BENNETT SUBDIVISION

Engineering Comments: FINAL PLAT COMMENTS (should be addressed prior to submitting the FINAL PLAT for review and/or signature by the City Engineer):

APPLICATION NUMBER 7 DATE May 7, 2020

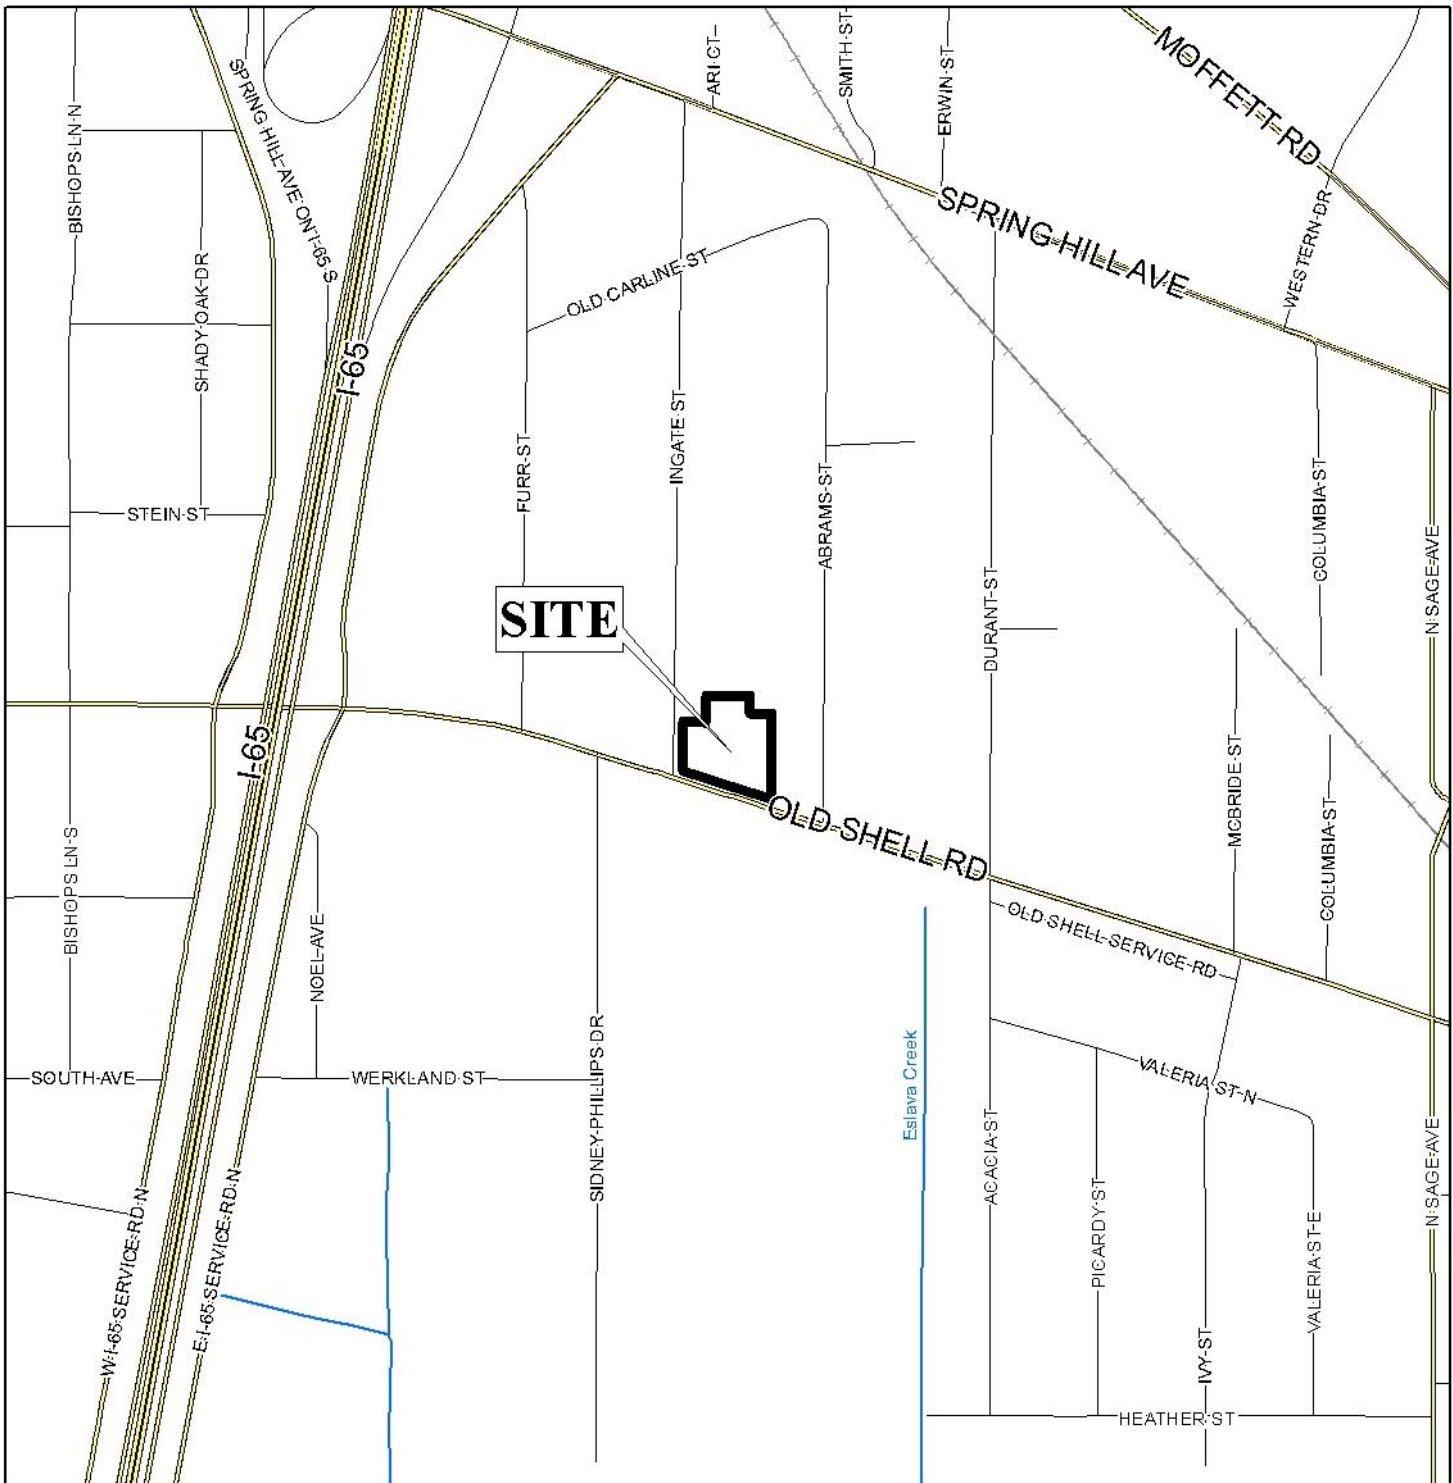
- A. Provide all of the required information on the SUBDIVISION PLAT (i.e. signature blocks, signatures, certification statements, written legal description, required notes, legend, scale, bearings and distances) that is required by the current Alabama State Board of Licensure for Professional Engineers and Land Surveyors.

- B. Show and label the POB.
- C. Clarify the two (2) property corners labeled “IRF”. The legend says they are “IRON ROD FOUND” however the written description describes them as CAPPED REBAR FOUND”.

- D. Provide the Surveyor’s, Owner’s (notarized), Planning Commission, and Traffic Engineering signatures.
- E. Add a note to the SUBDIVISION PLAT stating that as shown on the 1984 aerial photo (FLIGHT 24 - #74) LOT 1 will receive historical credit of existing (1984) impervious area towards stormwater detention requirement per Mobile City Code, Chapter 17, Storm Water Management and Flood Control) as follows: LOT 1 – 3,000 sf.

- F. Check and revise, or clarify PLAT NOTE #2 AND #3. No PUD was submitted for this application.
- G. Add a note to the plat stating that all proposed detention facilities, common areas, and wetlands shall be the responsibility of the Property Owner(s), and not the responsibility of the City of Mobile.

- H. Add a note to the plat stating that all easements shall remain in effect until vacated through the proper Vacation process.
- I. Provide a copy of the FINAL SUBDIVISION PLAT and LETTER OF DECISION to the Engineering Dept. for review. No signatures are required on the drawing. Place the information for the Subdivision Plat on the PLAT Review sign-in sheet.

The site has frontage along both Old Shell Road and Ingate Street. Both are minor streets at this location, with Ingate Street having curb and gutter, and Old Shell Road not having curb and gutter. Typically, Ingate Street would be required to have a 50 foot right-of-way, and Old Shell Road would be required to have a 60 foot right-of-way. However, a subdivision approved by the Planning Commission in 2001 for the site at the Northwest corner of Old Shell Road and Ingate Street did not require any additional dedication along Old Shell Road, making a waiver of V.B.14. of the Subdivision Regulation appropriate. Also, the applicant should coordinate with

the City Engineer to determine if a corner radius dedication is required, per Section V.D.6. of the Subdivision Regulations.

It should be noted that no setbacks are depicted on the preliminary plat submitted. If approved, 25' minimum building setback lines should be shown along both frontages.

As on the preliminary plat, the lot size label should be retained in both square feet and acres on the Final Plat, or a table should be furnished on the Final Plat providing the same information, adjusted for dedication. No easements are indicated on the preliminary plat. If any easements are recorded on the site they should be indicated and labeled on the Final Plat, and a note should be placed on the Final Plat stating that no structure may be placed or constructed within any easement.

Based on the preceding, with a waiver of Section V.B.14. of the Subdivision Regulations, this application is recommended for Tentative Approval subject to the following conditions:

- 1) recording of the Final Plat in Probate Court, and submittal of seven (7) copies to Planning & Zoning prior to issuance of a Final Certificate of Occupancy;

- 2) coordination with the City Engineer to determine if dedication of a corner radius of Old Shell Road and Ingate Street is required per Section V.D.6. of the Subdivision Regulations;

- 3) revision of the plat to illustrate the 25' minimum building setback line along both street frontages;
- 4) retention of the lot size in both square feet and acres, or the furnishing of a table on the Final Plat providing the same information, adjusted for dedication;

- 5) placement of a note on the Final Plat stating that no structure may be constructed or placed within any easement, if applicable;
- 6) compliance with the Engineering comments: *(FINAL PLAT COMMENTS (should be addressed prior to submitting the FINAL PLAT for review and/or signature by the City Engineer): A. Provide all of the required information on the SUBDIVISION PLAT (i.e. signature blocks, signatures, certification statements, written legal description, required notes, legend, scale, bearings and distances) that is required by the current Alabama State Board of Licensure for Professional Engineers and Land Surveyors. B. Show and label the POB. C. Clarify the two (2) property corners labeled "IRF". The legend says they are "IRON ROD FOUND" however the written description describes them as CAPPED REBAR FOUND". D. Provide the Surveyor's, Owner's (notarized), Planning Commission, and Traffic Engineering signatures. E. Add a note to the SUBDIVISION PLAT stating that as shown on the 1984 aerial photo (FLIGHT 24 - #74) LOT 1 will receive historical credit of existing (1984) impervious area towards stormwater detention requirement per Mobile City Code, Chapter 17, Storm Water Management and Flood Control) as follows: LOT 1 – 3,000 sf. F. Check and revise, or clarify PLAT NOTE #2*
